**TOWN OF CARMEL**  
**PLANNING BOARD**

**PLANNING BOARD AGENDA**  
**AUGUST 5, 2015 – 7:00 P.M.**

RE: Baldwin Subdivision  
Route 6  
Tax Map No. 86.11-1-1

RE: PCSB Site Plan  
Route 6  
Tax Map No. 86.11-1-1 – Proposed Lot 1

DRAWING: **OVERALL PLAN**

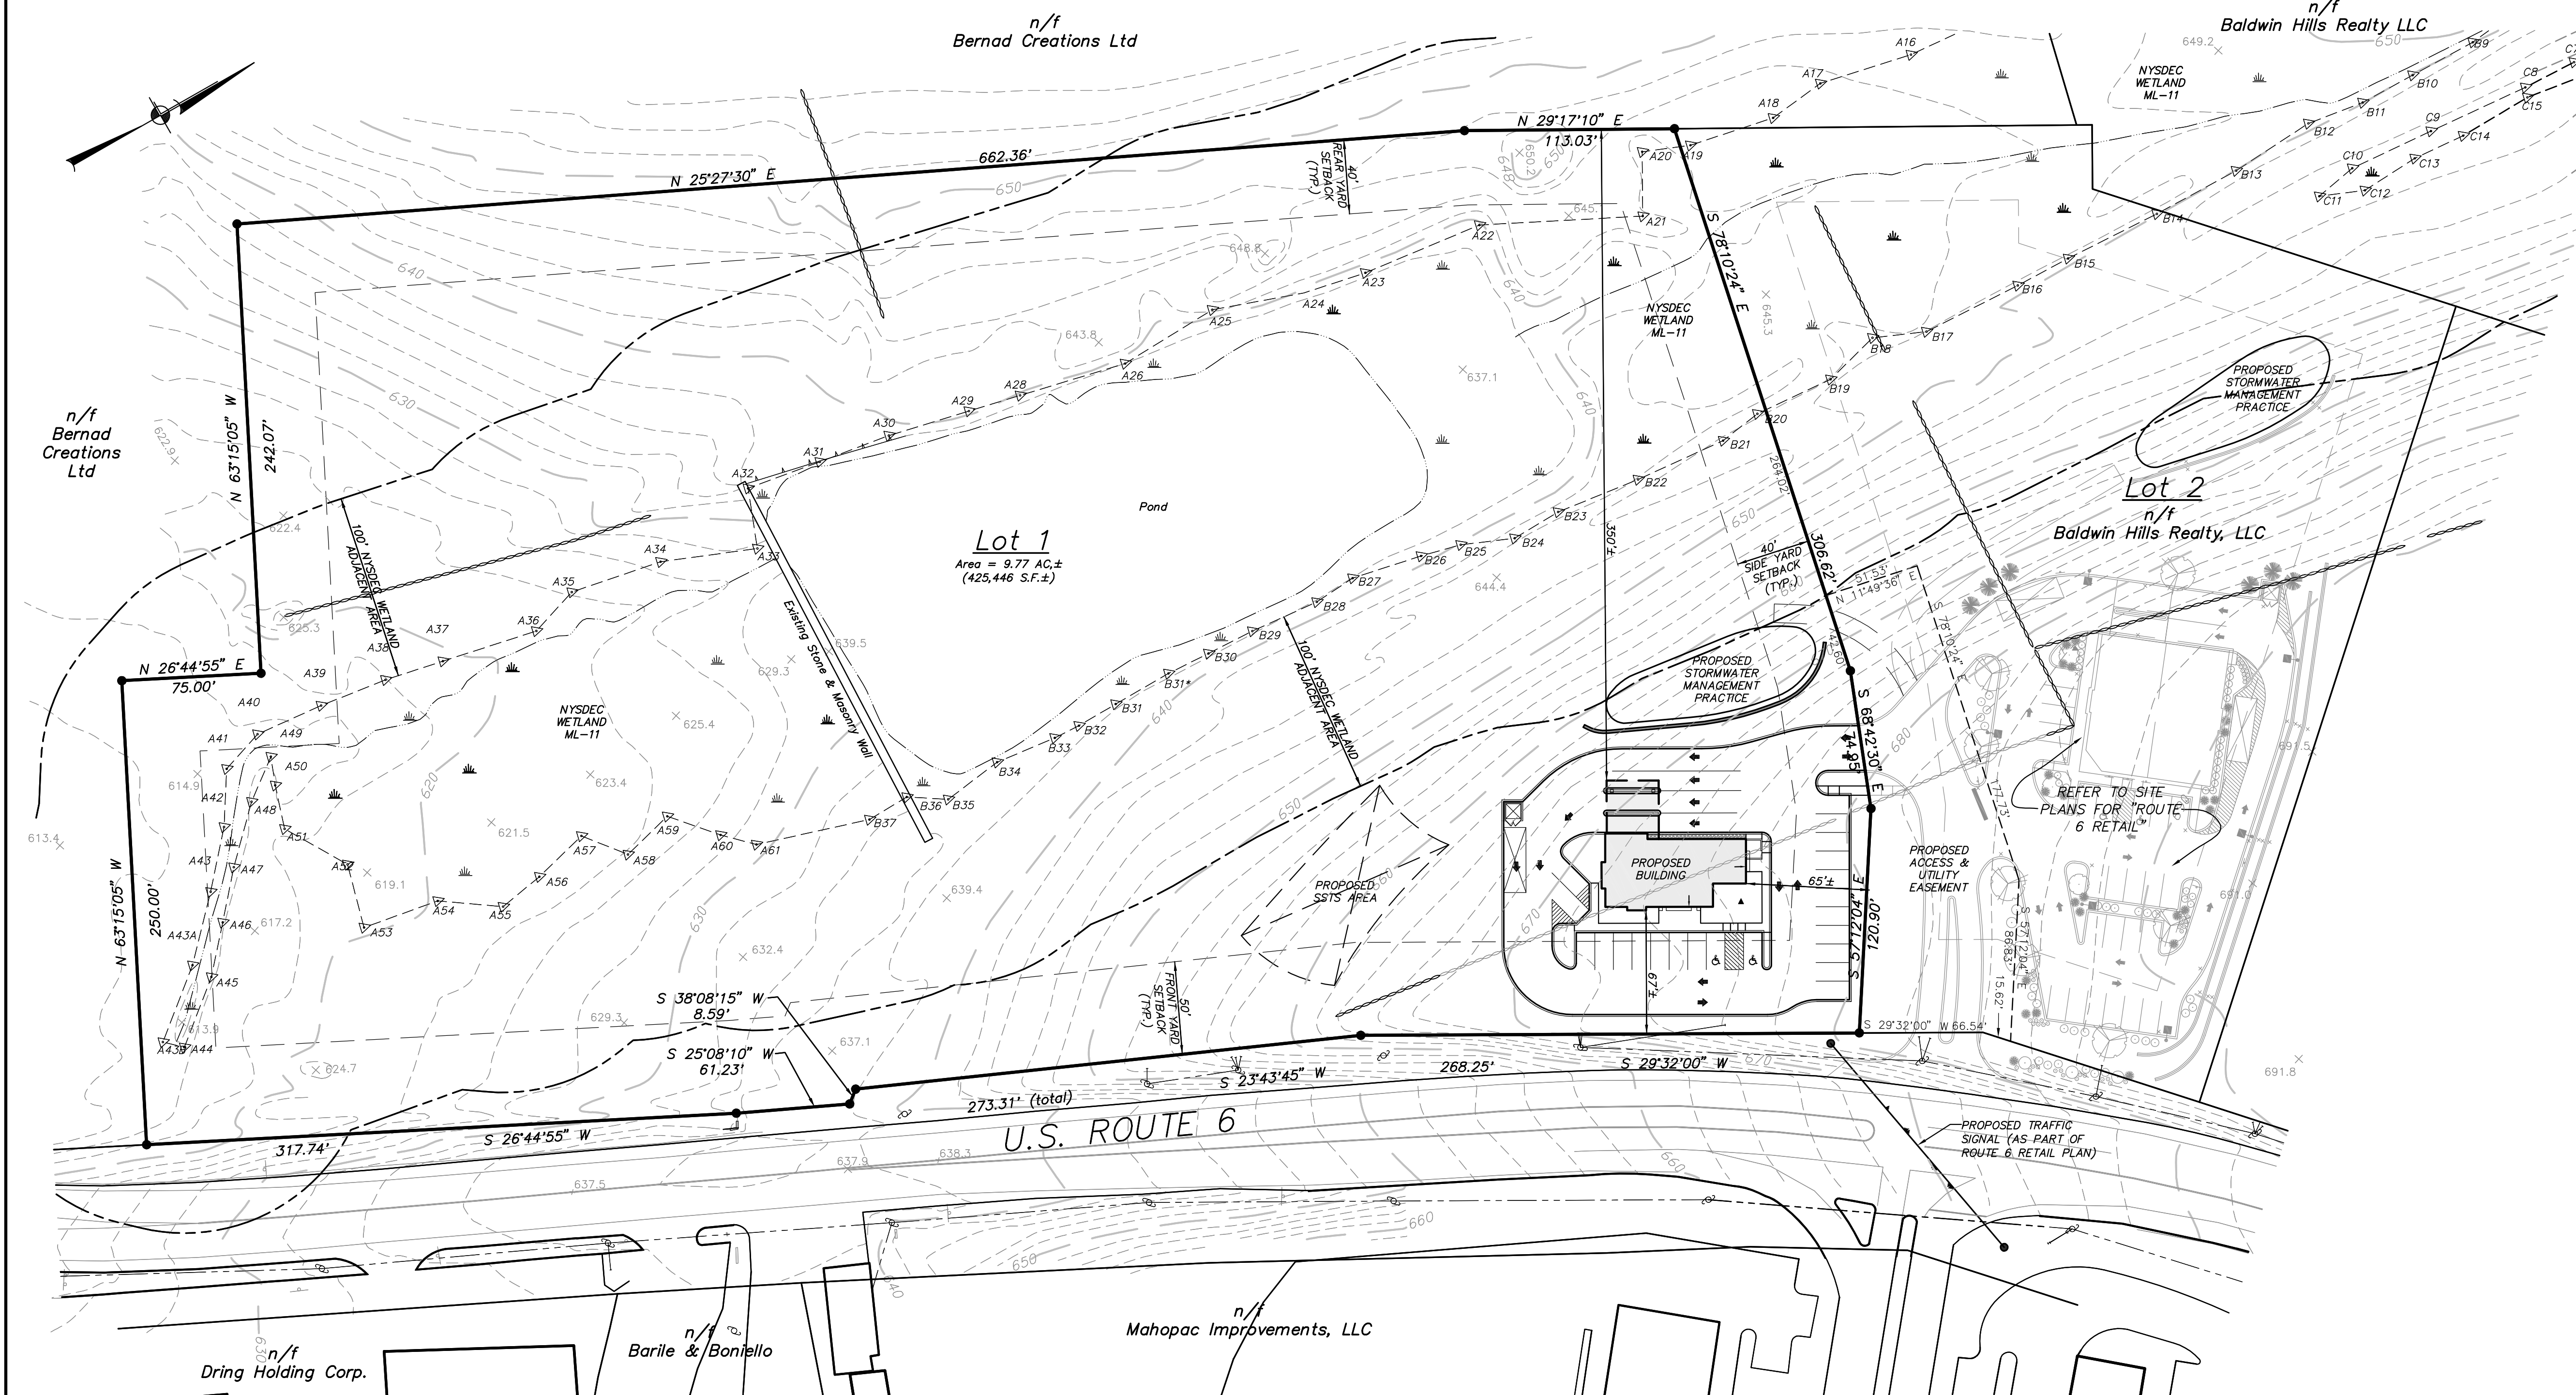
1. Overall Plan – OP-1
  - a. Maser Consulting is working with the NYSDOT relative to the Route 6 traffic improvements associated with the entrance to the project. Should available sight distances be required to be evaluated as part of the proposed traffic improvements, these will be established and reviewed by the NYSDOT.

- b. The feature at the south side of the pond has been labelled on the site plan.
  - c. The feature located on the south east corner of the site has been removed from site plan.

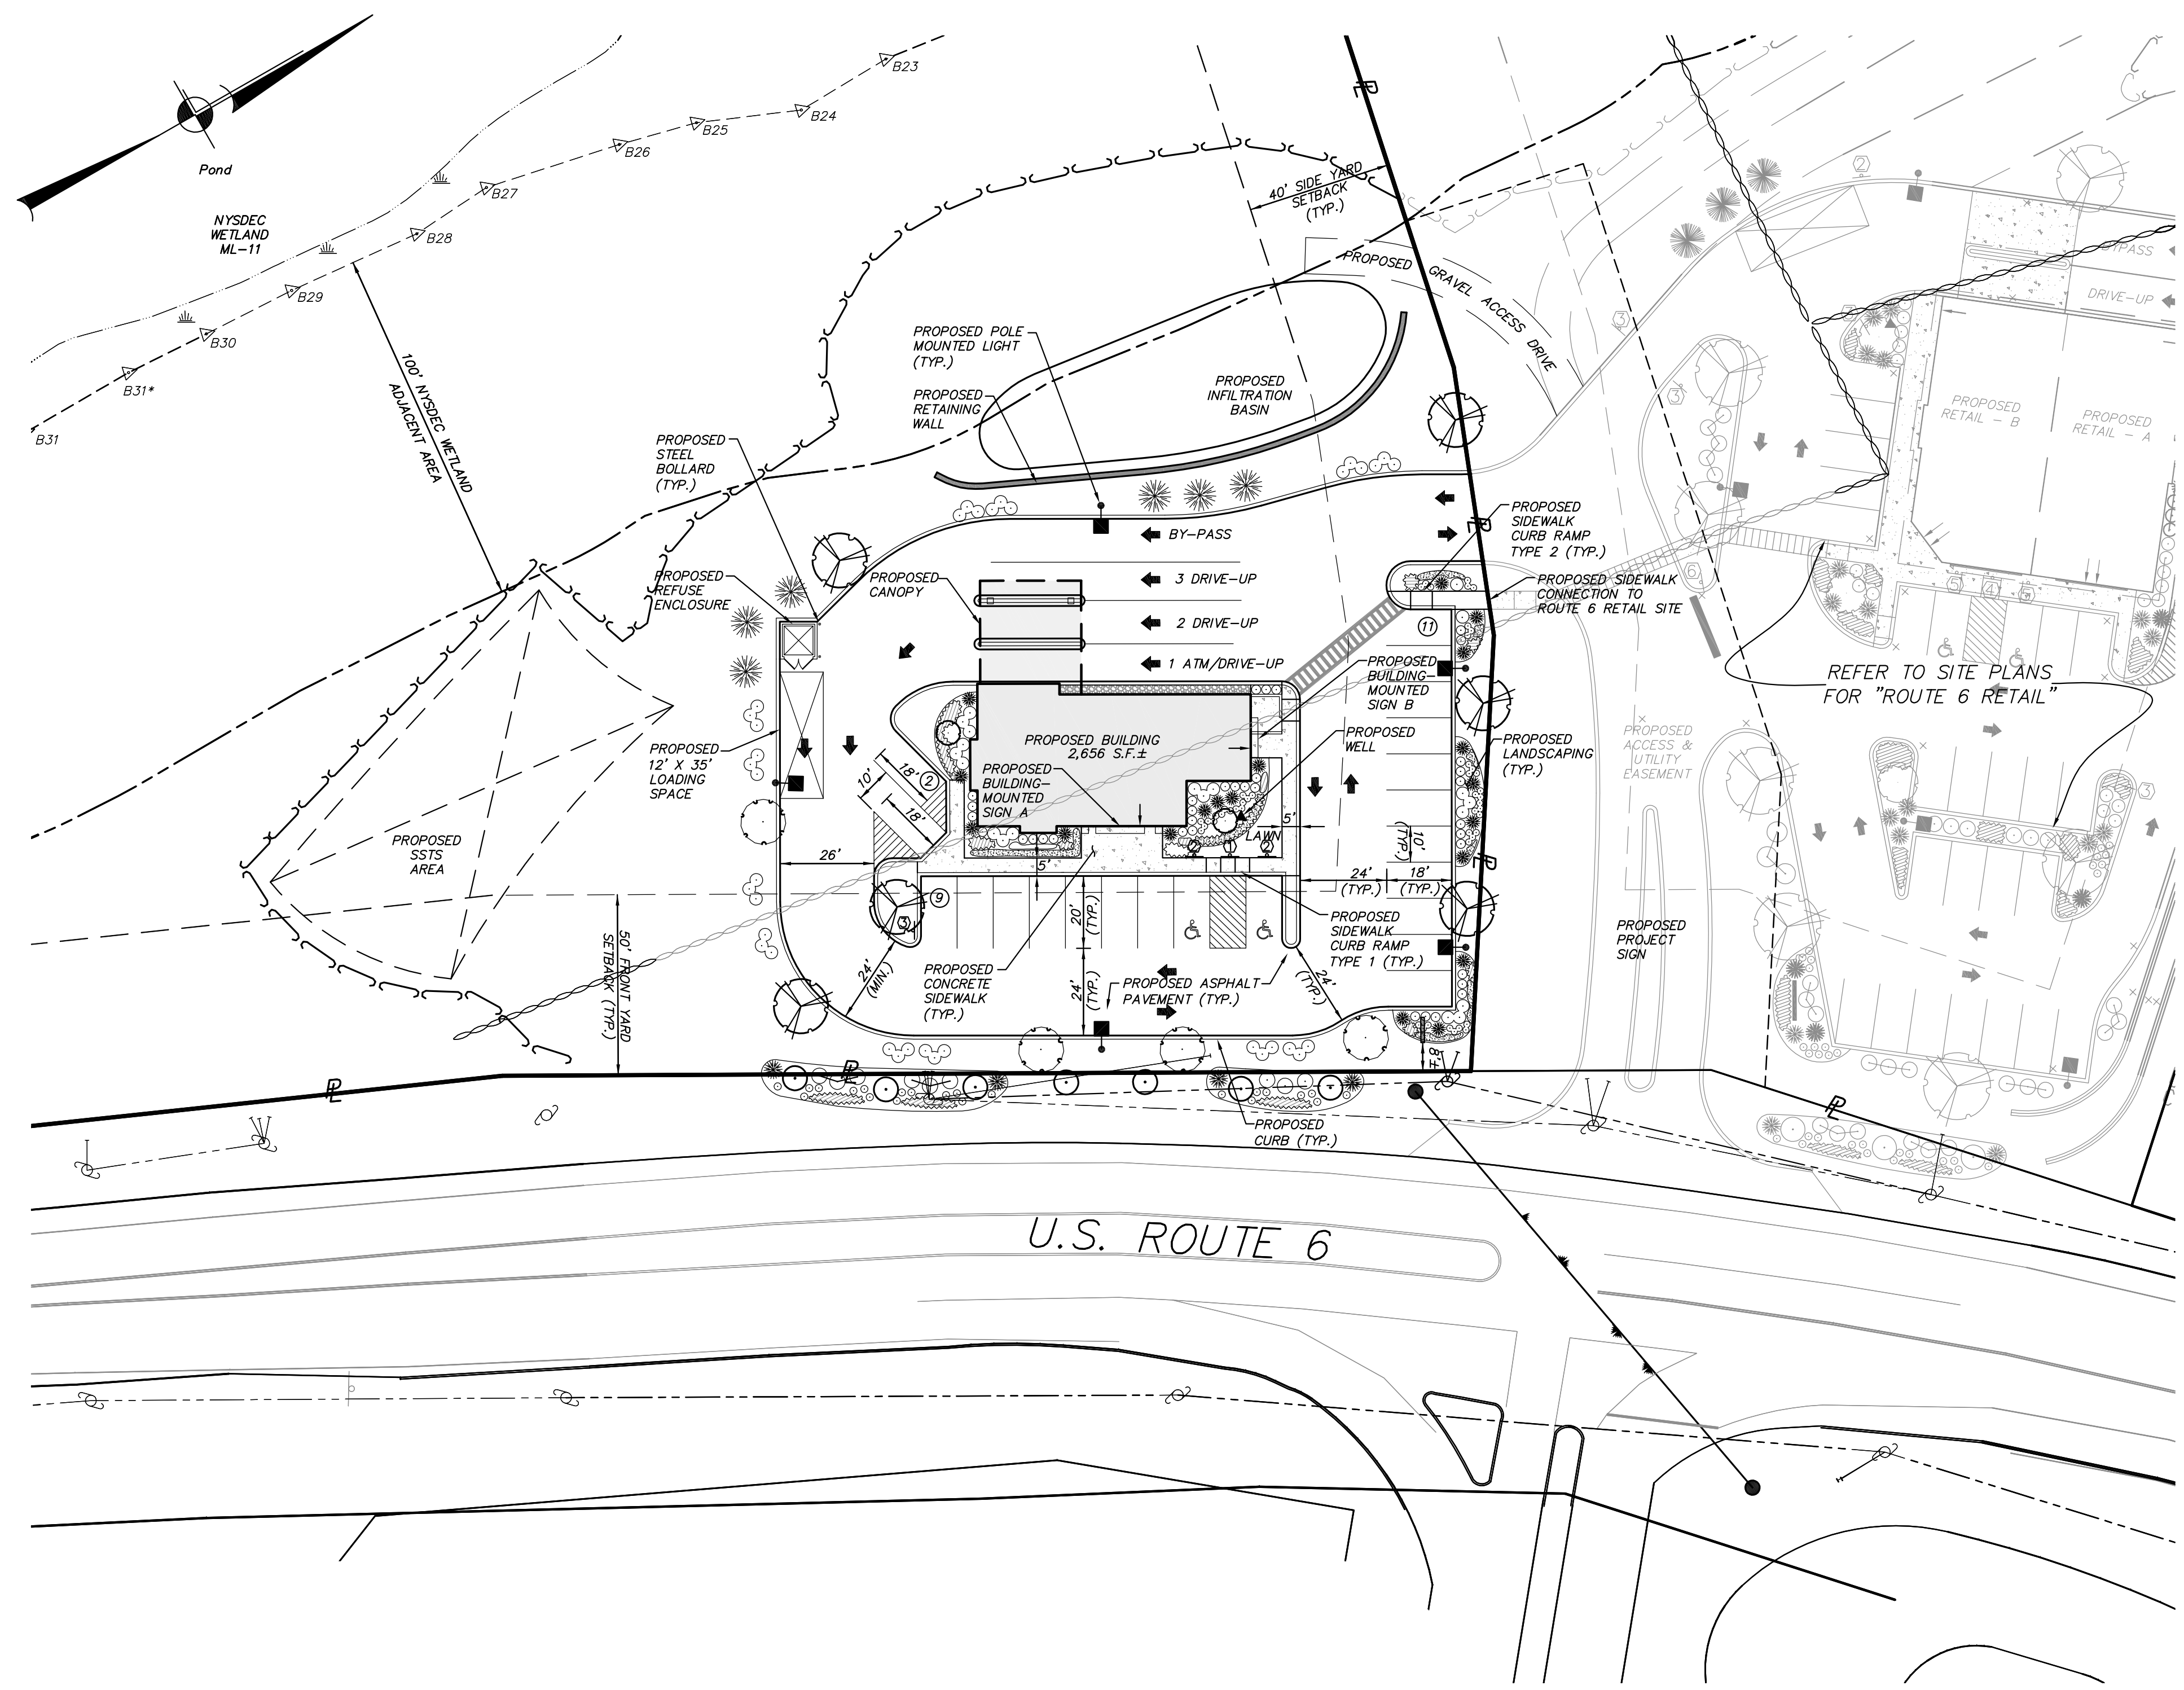
2. Layout and Landscape Plan – SP-1
  - a. The agreements/easements for site access, SMPs and utilities will be provided in a later submission
  - b. It is understood that all plantings should be verified by the Town of Carmel Wetlands Inspector.

- c. It is understood that all plantings shall be installed per Section 142 of the Town of Carmel Code.
  - d. The traffic signal has been labelled as proposed on the site plan.

- e. A lighting photometric plan shall be provided in a later submission.
  - f. The legend has been updated to identify the proposed pole-mounted light symbol.

- i. The proposed plantings at the south east corner have been relocated to not extend off-site, therefore an easement is not required.

DRAWING:  
GRADING & DRAINAGE PLAN

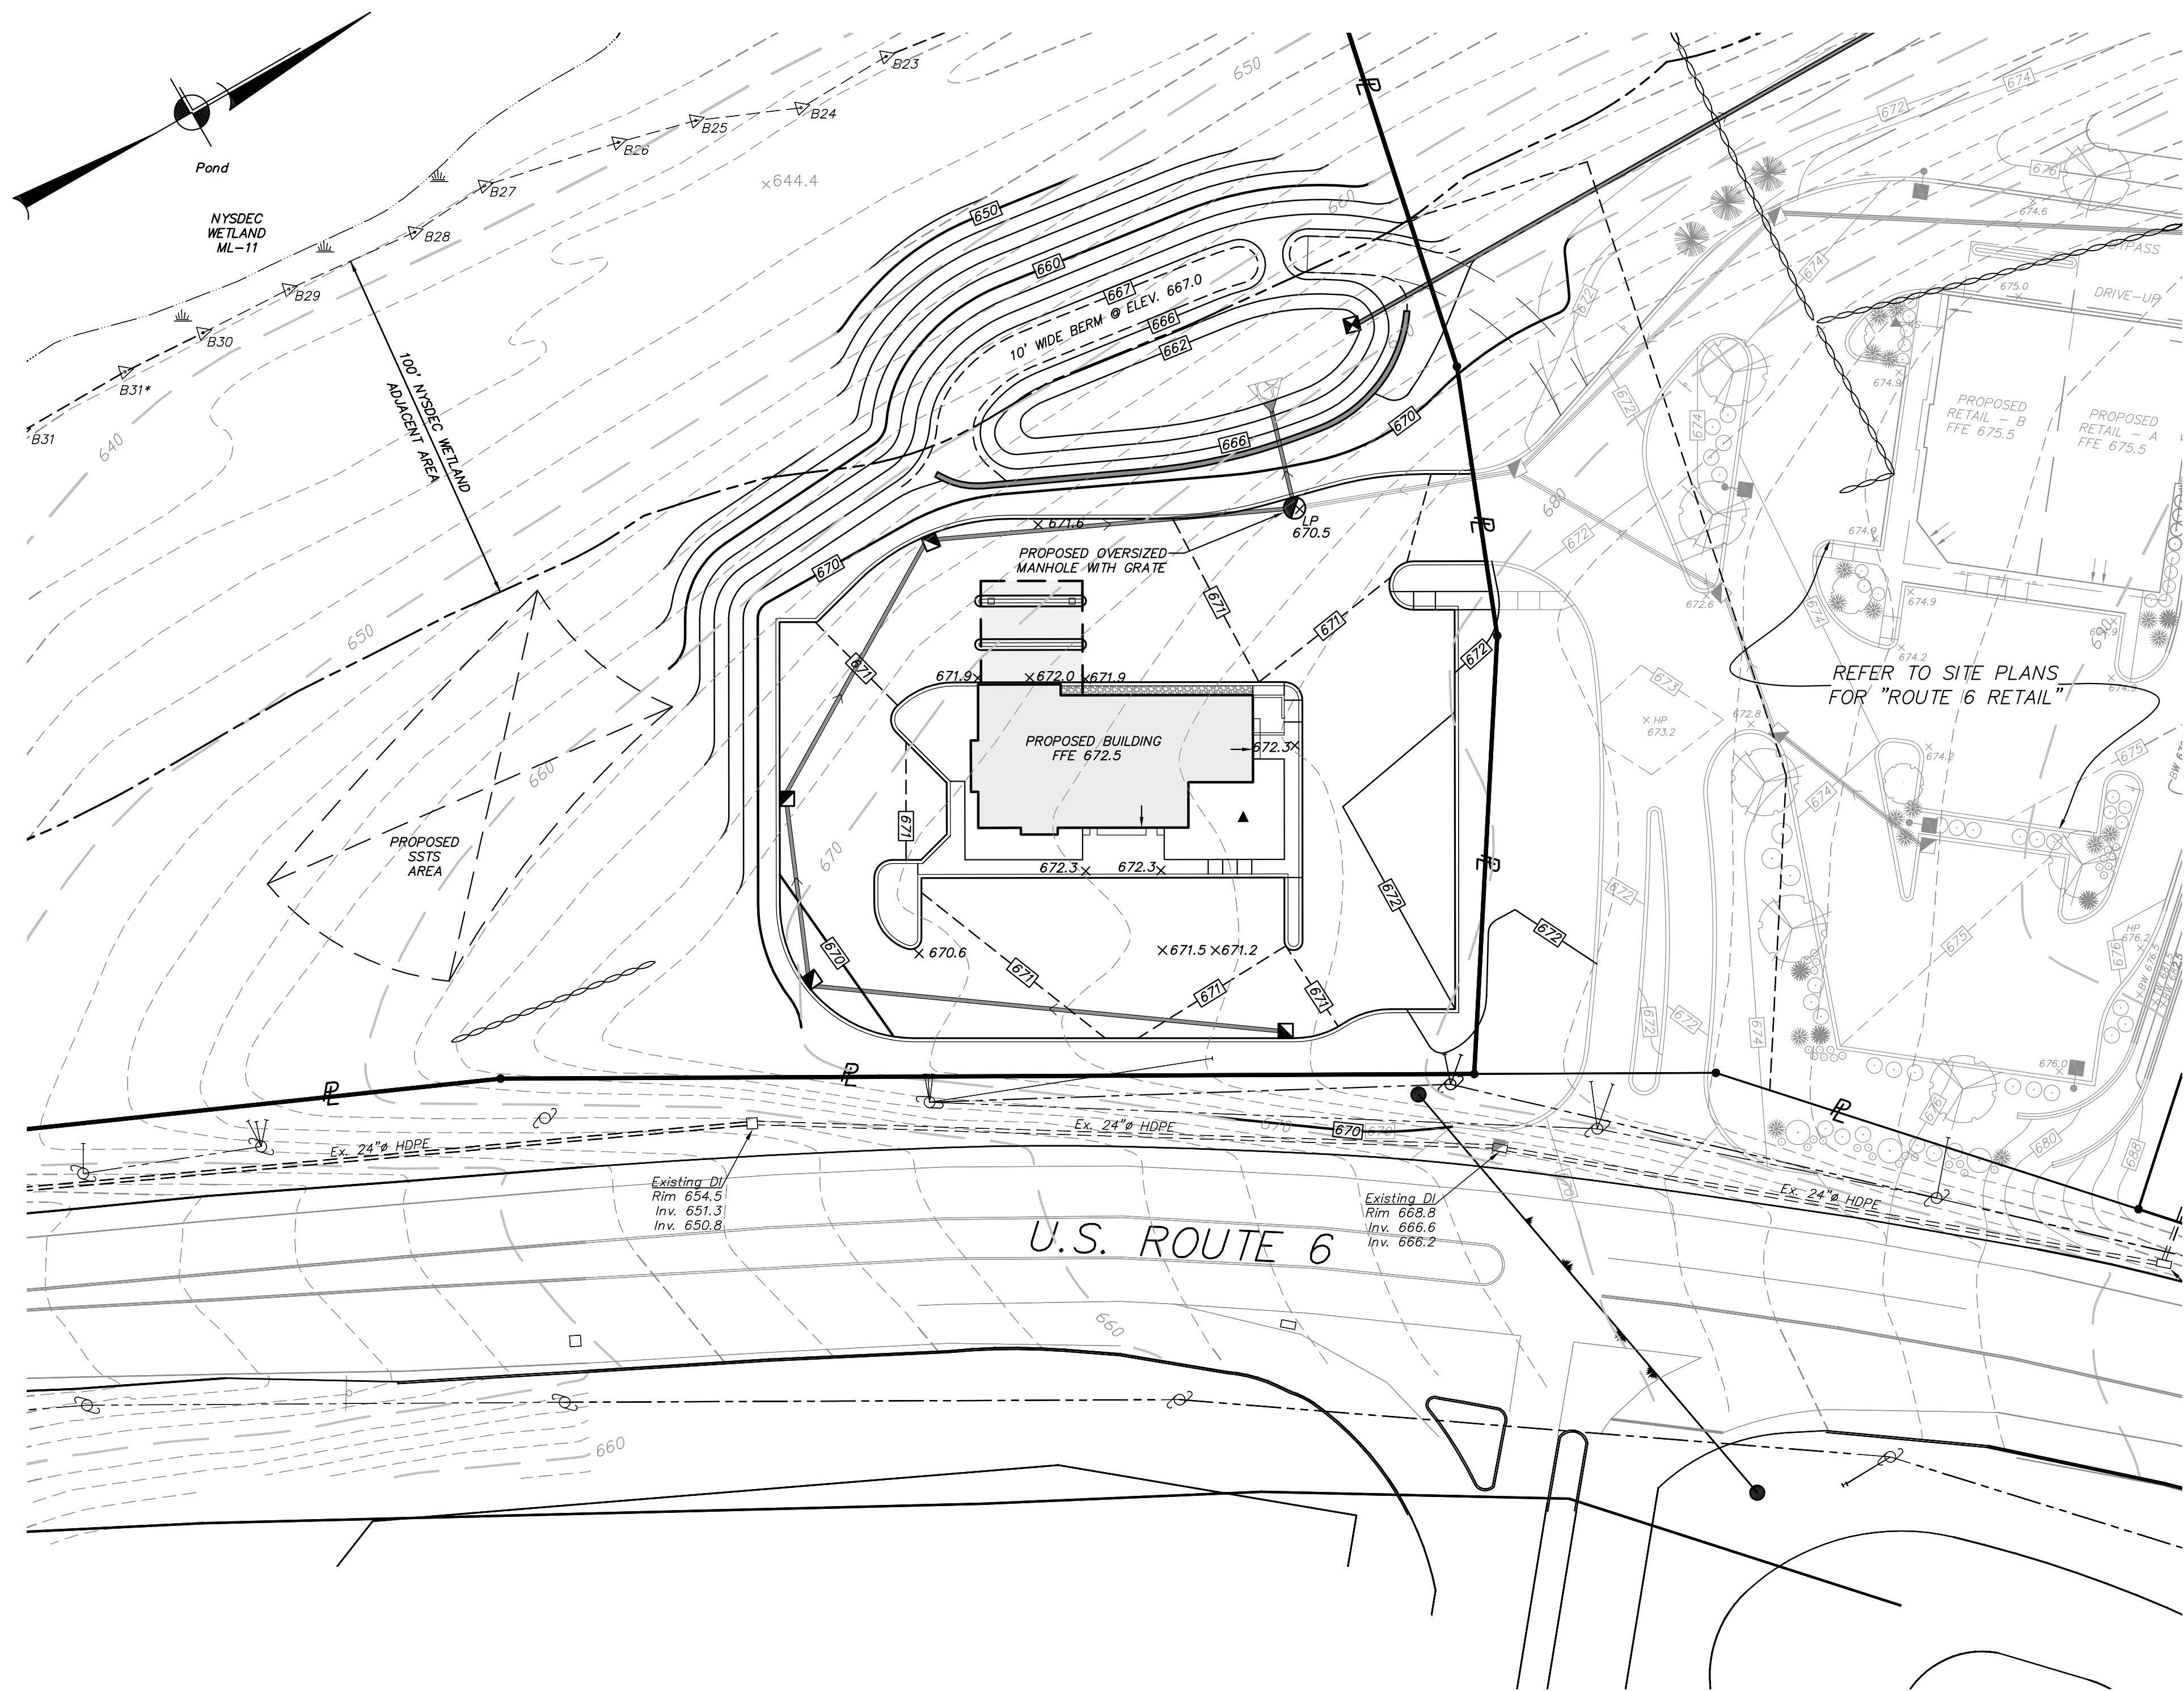
3. Grading and Utilities Plan – SP-2
  - a. Rim and invert elevations shall be provided in a later submission.
  - b. Hydraulic calculations and pipe sizes shall be provided in a later submission.

- c. The labels for contour elevations along the SMP have been revised accordingly.
  - d. More detailed utility information shall be provided in a later submission. The details for the proposed well and septic shall be reviewed by the Putnam County Dept. of Health.

- e. See response to Item 3.d. above.
  - f. See response to Item 3.d. above.
4. Erosion and Sediment Control Plan – SP-3
  - a. Rim and invert elevations shall be provided in a later submission.
